Proposal to amend GRE/2020/04 Rev.1

A. New Supplement to the 06 and 07 series of amendments to UN Regulation No. 48

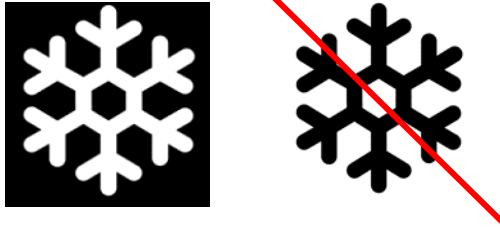
6.22.9.3.2.1. The lateral distance from the outer edges of the driver assistance projections on the road with respect to the trajectory of the centre of gravity of the vehicle shall not be more than 1,875 mm. This shall be demonstrated by the manufacturer by calculation or by other means accepted by the Type Approval Authority.

Symbols and patterns for the use as driver assistance projections

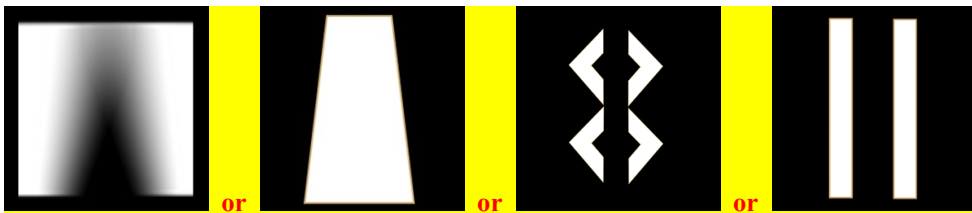
1. Symbol for slippery road warning

2. Symbol for collision warning

3. **Pattern for guidance**
